HICKORY CREEK ESTATES

WICHITA, SEDGWICK COUNTY, KANSAS

RE: S/D 95-60 - Final Plat of Hickory Creek Addition

RE: S/D 95-60 - Final Plat of Hickory Creek Addition

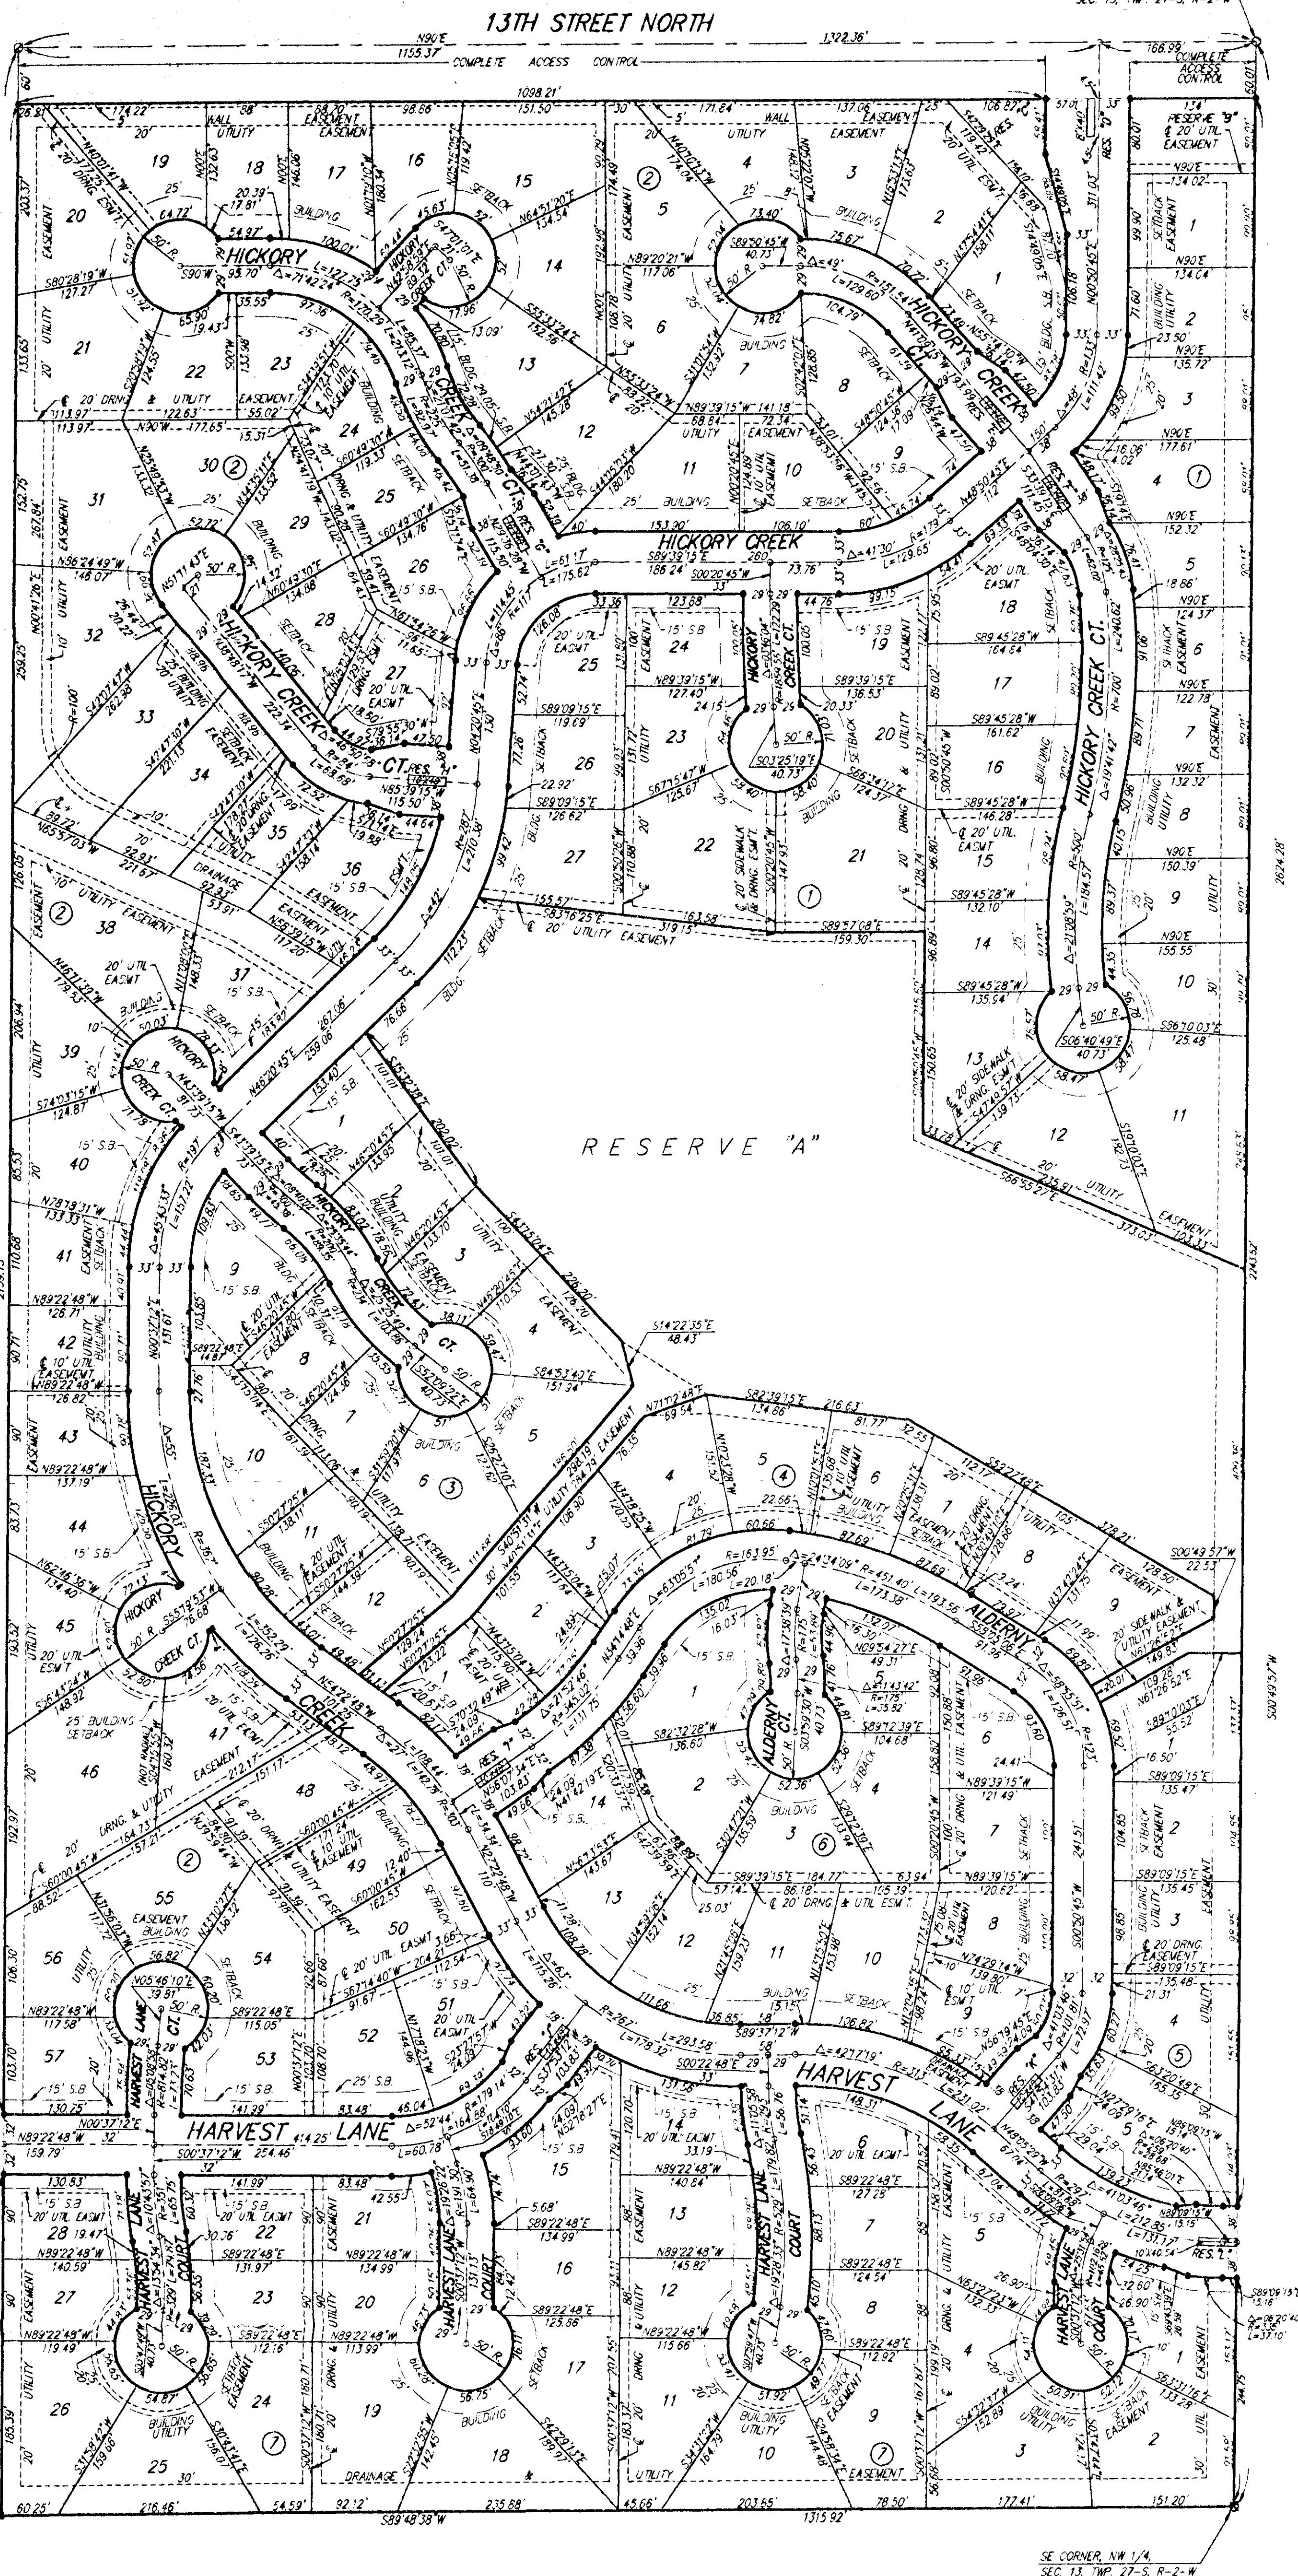
- A. Prior to this plat being forwarded to the Wichita City Council for approval, this site will need to have been annexed to Wichita. Upon annexation, this property will be zoned City "AA" one-family and will allow the lot sizes being platted.

- B. The applicant shall guarantee the extension of sanitary sewer to serve the lots being platted. The applicant shall also submit calculations needed to determine the capacity of a lift station needed to serve this site. If determined necessary by City Engineering, guarantees shall also be provided for any needed improvements to this lift station.

- C. The applicant shall guarantee the extension of City water to serve the lots being platted. This guarantee shall also provide for the extension of water across this site's frontage to 13th Street North.

- D. The applicant shall guarantee the paving of the proposed interior streets. This guarantee shall also provide for sidewalks. As a collector street, sidewalk is required along both sides of Hickory Creek/Azure. Sidewalks shall also be provided along one side of the section of Azure which extends westward into the abutting property.

While the need for sidewalks on both sides of a collector is typically considered essential because of concerns with safety, this plat's design involving a large Reserve, access easements or extensions of the Reserve and other streets paralleling the collector street suggests that one portion of the required collector sidewalks could be routed along an alternative path. If the applicant desires, an alternative sidewalk should be provided for consideration. That is, a sidewalk along one-side of the collector would still be required with the second section of sidewalk potentially following an alternate route; providing that

- E. As requested by City Engineering, the applicant shall provide appropriate guarantees to participate in the paving of 13th Street North adjacent to this site.

- F. The applicant shall guarantee any drainage improvements required by the platting of this property. As requested by City Engineering, additional drainage information is needed before the drainage plan can be approved. Also any additional easements or widening of drainage easements determined necessary shall be provided for on the final plat tracing.

- G. The applicant shall guarantee construction of the storm sewers required by this plat.
- H. If improvements are guaranteed by petition, a notarized certificate listing the petitions shall be submitted to the Planning Department for recording.

- I. Provisions shall be made for ownership and maintenance of the proposed reserves. The applicant shall either form a lot owners' association prior to recording the plat or shall submit a covenant stating when the association will be formed, when the reserves will be deeded to the association and who is to own and maintain the reserves prior to the association taking over those responsibilities. Further, this covenant shall provide for the homeowners' association to maintain the "parking strip" area located between this plat's north line and the driving surface for 13th Street North.

- K. The applicant shall submit a covenant which provides for four (4) off-street parking spaces per dwelling unit on each lot which abuts a 58-foot street. The covenant shall inventory the affected lots by lot and block number and shall state that the covenant runs with the land and is binding on future owners and assigns.

- L. The final plat tracing shall indicate on the face of the plat complete access control to 13th Street North from the adjacent lots and Reserves (D & C).

- U. The final plat shall indicate the utility easements requested by K.G.& E. which are indicated on the enclosed "marked" copy of the plat.
